Work Order ID 68566

Item Name: 205 Skidtube bent detail

DRAWING NO.	TITLE	REV.	DART AEROSPACE LTD	D.E.O. NO.	SHEET NO.	SCALE
D2580	205 SKIDTUBE ASSEMBLY	D	ENGINEERING ORDER	D2580-D-1	SHEET 1 OF 1	NTS
DRAWN	CHECKED		MFG. APPR.	APPROVED	DE APPR.	
DATE 10.09.22	DATE 10-11-04		DATE 10.11.04	DATE 15/11/04	DATE 10-11-04

PURPOSE:
CHANGE ALL WELDED CROSSBOLT SPACERS TO SWAGED SPACERS

SECTION D-D & SECTION H-H ARE AMENDED AS FOLLOWS:

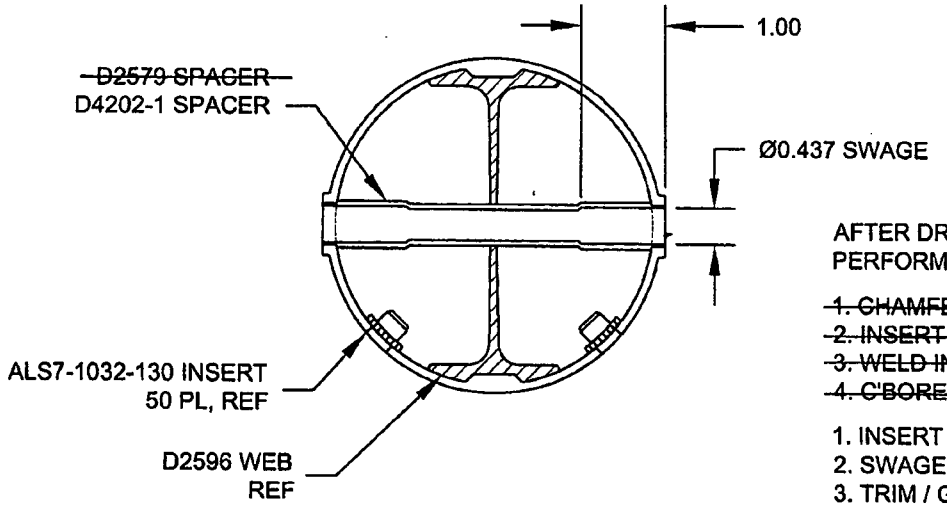
~~1. CHAMFER HOLE 0.050 X 45°~~
~~2. INSERT D2579 SPACER (20 PLACES)~~
~~3. WELD INTO PLACE AND GRIND FLUSH~~
~~4. C'BORE D2579 SPACER TO Ø0.437 X 1.00 DEEP~~

1. INSERT D4202-1 SPACER, 20 PL (-041) OR 24 PL (-045)
2. SWAGE TO Ø0.437 X 1.00 DEEP PER QSI 002
3. TRIM / GRIND FLUSH PER QSI 002
